HISTORIC DISTRICT COMMISSION
STAFF REPORT

5:30 pm • August 27, 2018 • City Hall

**ROBINSON HISTORIC DISTRICT
CERTIFICATE OF APPROPRIATENESS REVIEW
NEW SINGLE FAMILY RESIDENCE
815 MITCHELL STREET**

**OLD CONWAY DESIGN OVERLAY DISTRICT
CERTIFICATE OF APPROPRIATENESS REVIEW
FREESTANDING METAL VAN COVER
SE CORNER OF ROBINSON AVE & FAULKNER ST**

Site Plan

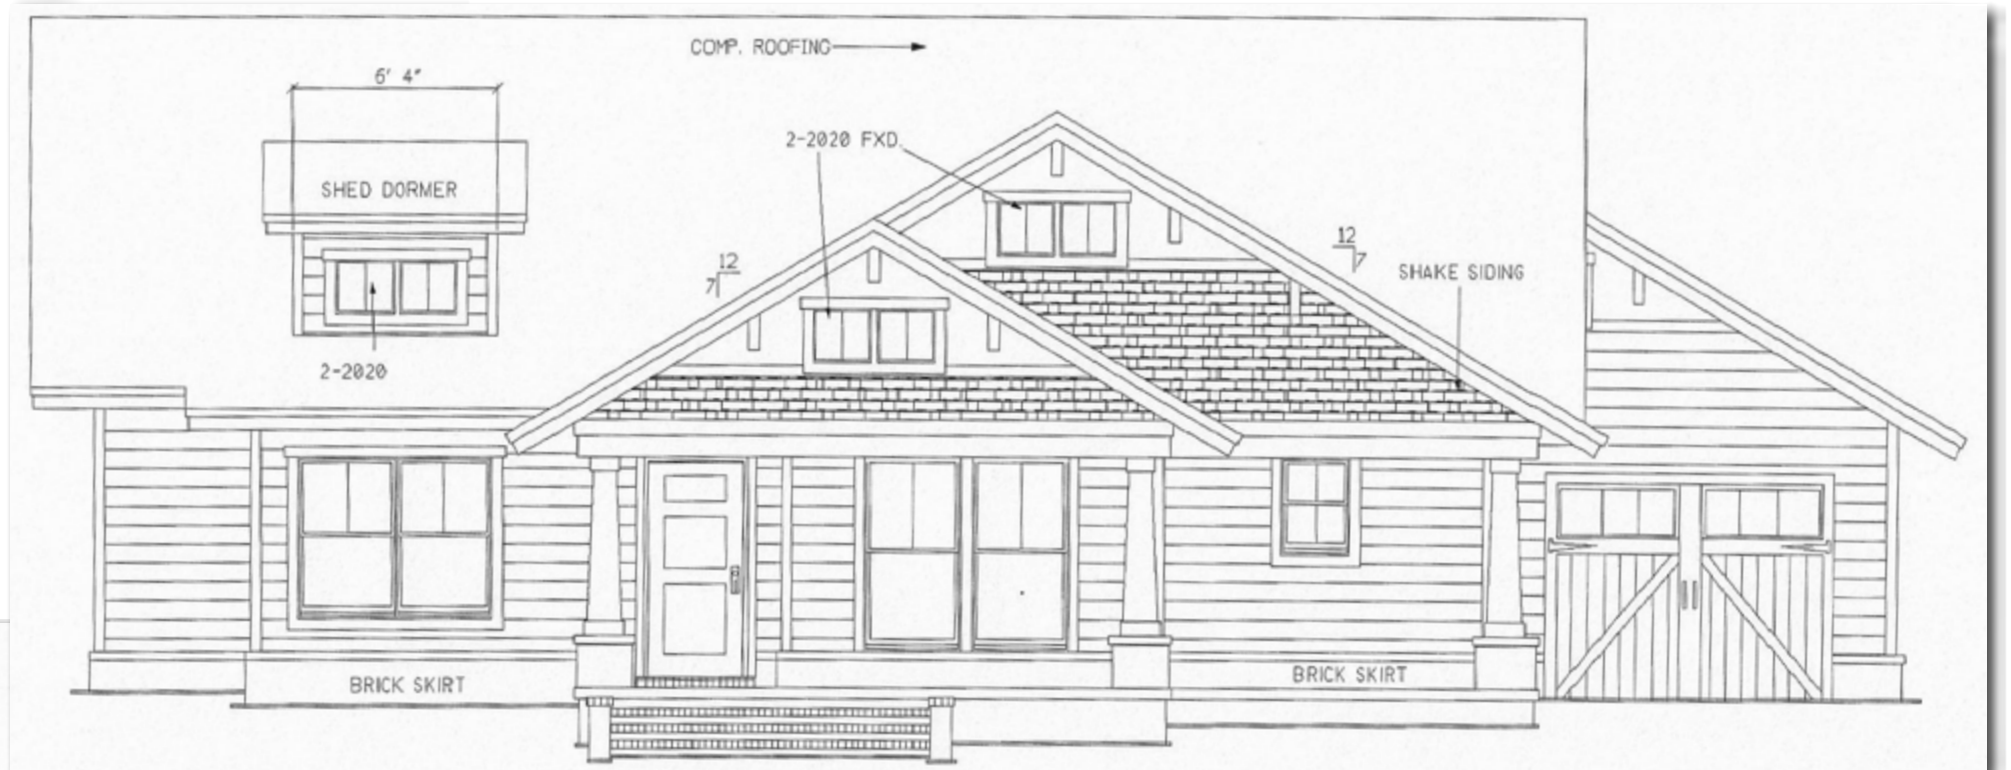
Driveway/Parking. An 10 foot wide concrete driveway is proposed on the north side of the residence. The driveway runs along the north side of the house to a turn around area accessing the rear garage.

Tree preservation. There is a 24"+ hackberry tree that appears to be in the center of the proposed driveway. The hackberry has been somewhat "hacked" by utility tree trimmers. There are existing overhead power lines. A remedial understory tree could be planted between the sidewalk and the new residence.

7. Wide trim around windows and doors and mixture of roofing shall be used as shown.
8. Driveway shall be 10 feet wide concrete driveway accessing the rear garage and turn around area.
9. HVAC and utility equipment shall be appropriately located at the rear or side of the structure and/or appropriately screened.
10. Any damage to the sidewalk during construction shall be repaired.

photo of actual freestanding carport

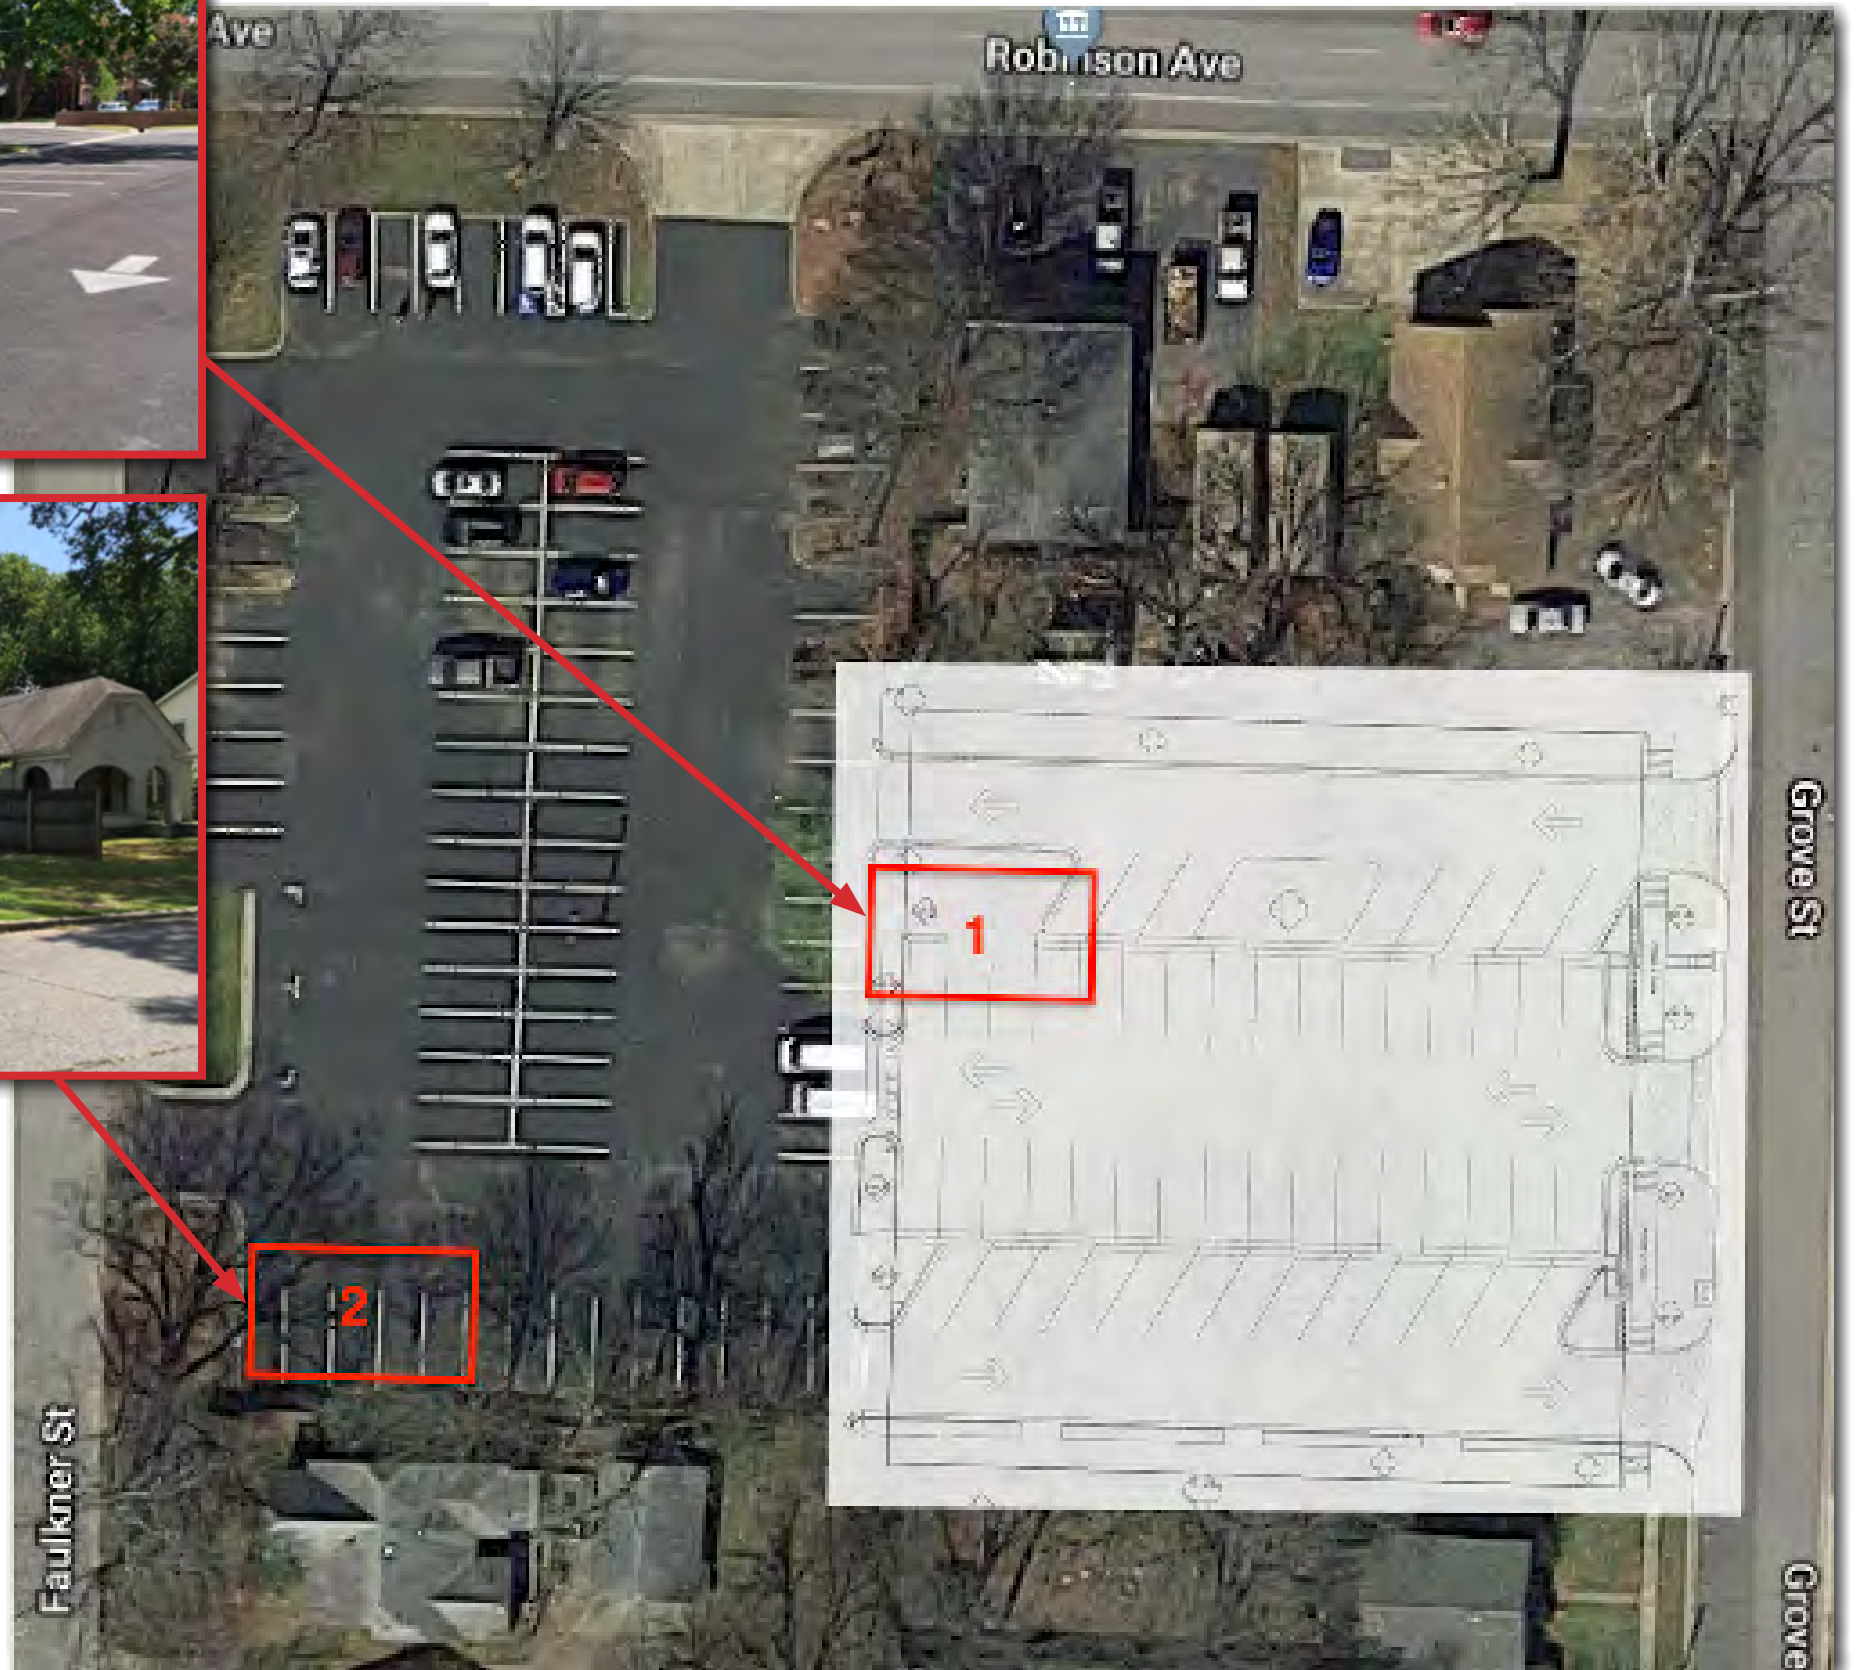
Scale. The size of new construction in relation to neighboring structures and the proportion of structures to the human scale. The van cover is 45 feet long by 24 feet wide and 13 feet tall. It covers 1080 square feet. This is quite large as an accessory structure. Some area homes are almost this size. The van cover constructed by the Church of the Nazarene one block south covers 720 s.f. The Church of the Nazarene cover is in the Old Conway Design Overlay.

Height. The average height of area structure's eaves and cornices. Also, the first floor elevation / height relationship. Roof height is around 13 feet tall to accommodate the large Church van.

Aerial View of proposed location 3 at 615 Faulkner St

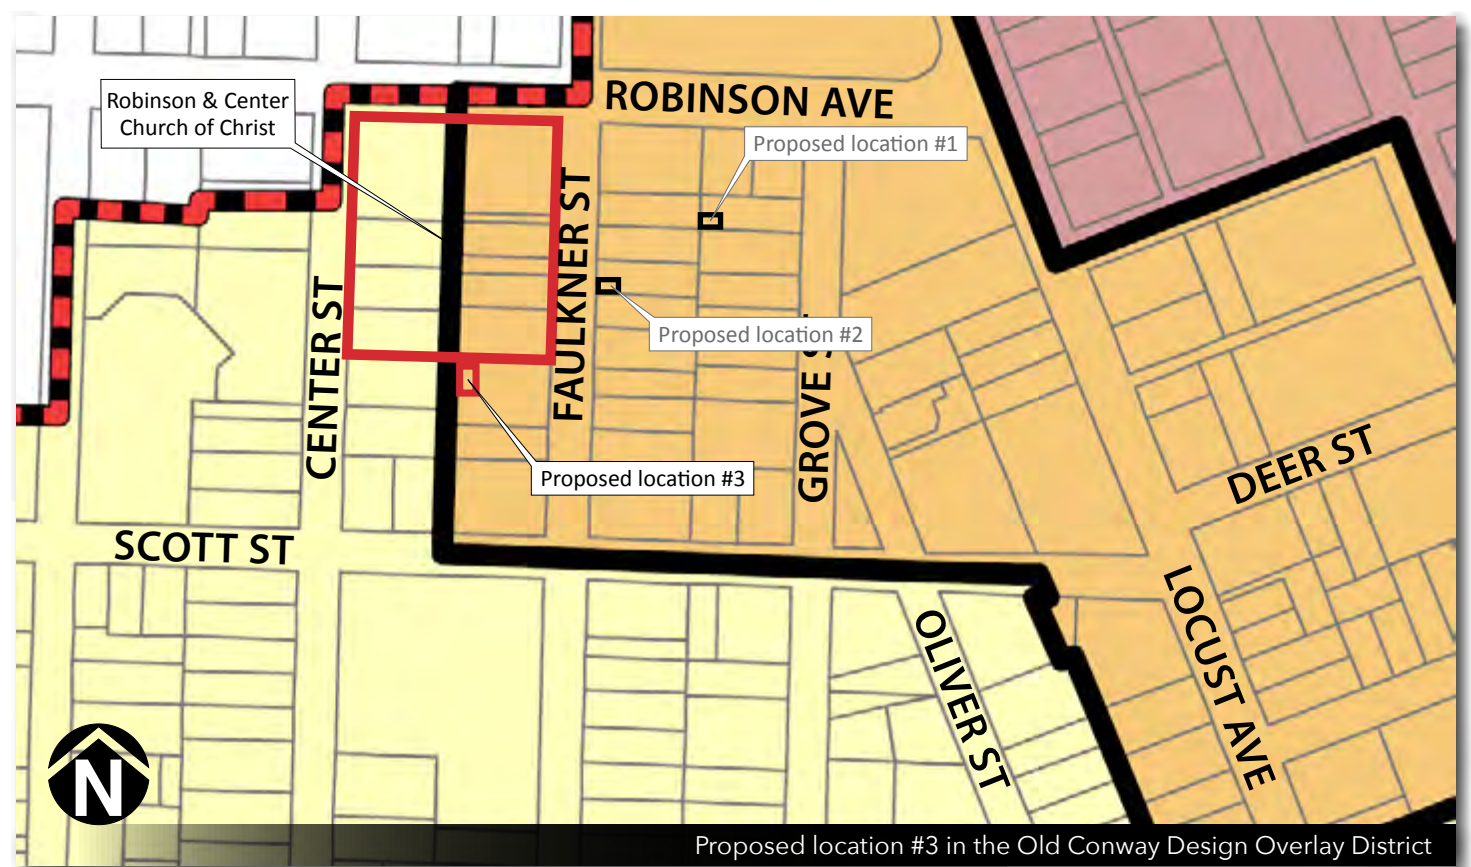
Setbacks. There appears to be around 40 feet from the back of the residence to the west fence and 60 feet from the end of the concrete drive to the north fence. The van cover is 24 feet wide by 45 feet long. There should be ample area to locate the cover and provide adequate setbacks.

Tree preservation. It appears that at least two large trees would need to be removed in order to place the van cover in the backyard. One is a very large mulberry tree, the other is a 14" pecan tree. Depending on exact placement, another 14" double trunk pecan tree might be affected in the northwest corner of the property. The mulberry tree is not in good health and is a non-native invasive tree.

- Possible conditions.
1. The van cover shall be located as proposed in the rear yard of 615 Faulkner Street.
 2. Parking surface under van cover? Gravel?
 3. Dead trees on the west end of the new parking lot expansion at SE corner of Robinson and Faulkner shall be replaced with a new 2" caliper tree of the same species.

Aerial view of 705 Davis St

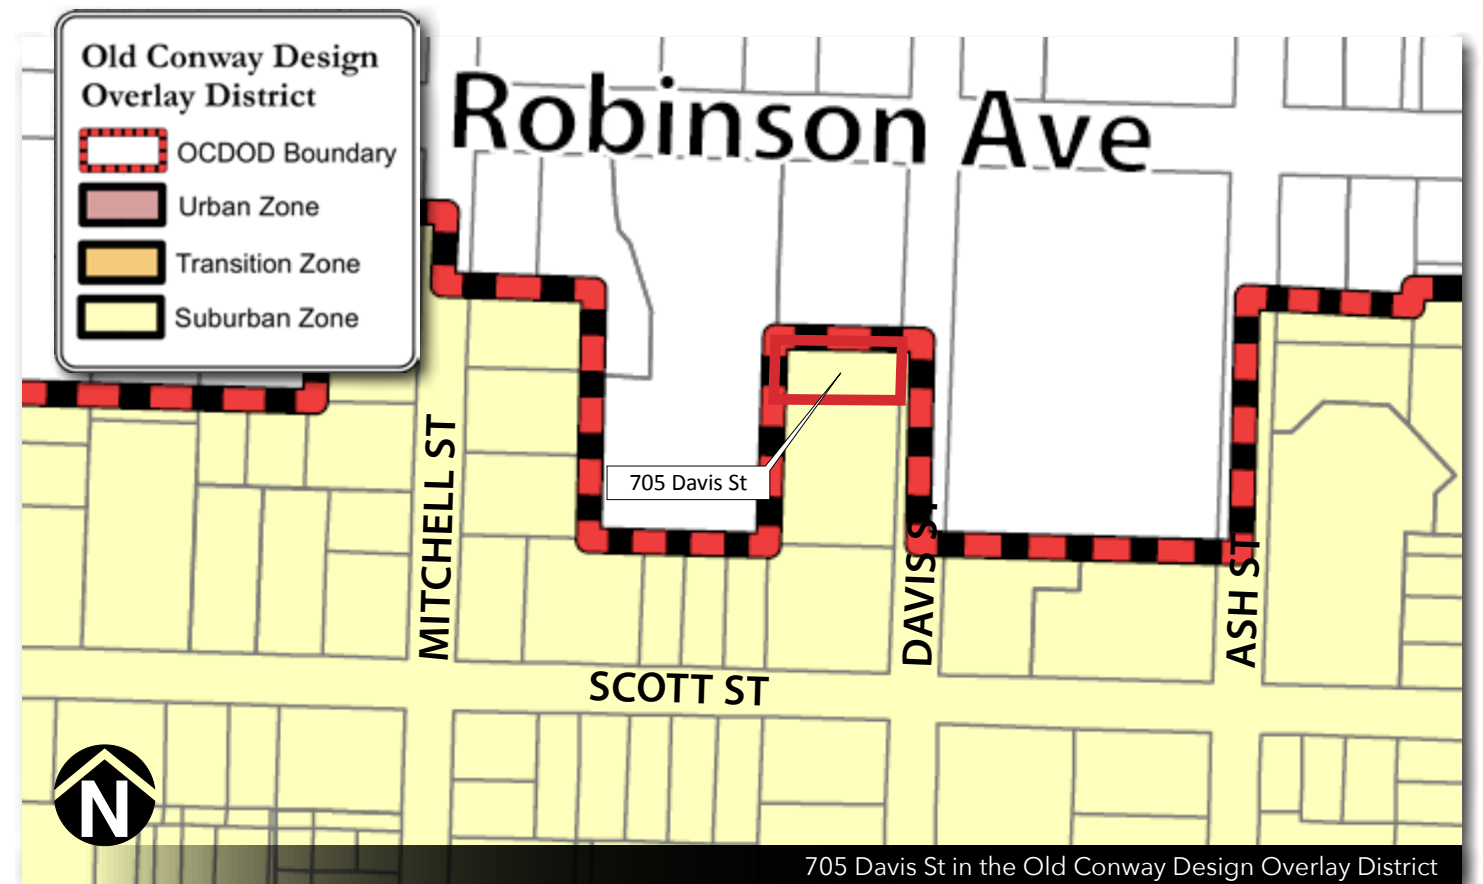
Setbacks. Proposed setbacks should respect the predominant setbacks of area structures, especially the front setback. Front setbacks are allowed within a range of 85% to 115% of the average area front setback. The average area setback from the curb is 46 feet yielding a range of 39-52 feet. The applicant would like to bring carport forward by 3 feet ± and enclose to create a garage creating a front setback at 34'-6" from the curb. The side and rear setbacks will remain unchanged. The house was historically expanded to essentially 0; side setbacks.

Sidewalks. There is an existing sidewalk along Davis Street. The sidewalk is in poor condition and will need to be repaired.

1. The residence's front setback shall be approximately X feet from the curb? - or -the residence's front setback shall remain unchanged. The carport may be extended to the rear? Side setbacks shall be allowed to continue at 0 feet.
2. New doors may be placed as shown. Original windows shall be retained and reused in the new addition.
3. Garage door - require two doors, windows and/or additional detailing?
4. Shutters should (shall) be removed.
5. Original windows shall be retained and repaired throughout the residence.
6. Moulding trim matching historic trim shall be used around windows and doors.
7. Asphalt roof matching existing shall be used.
8. The existing Davis Street sidewalk shall be repaired.
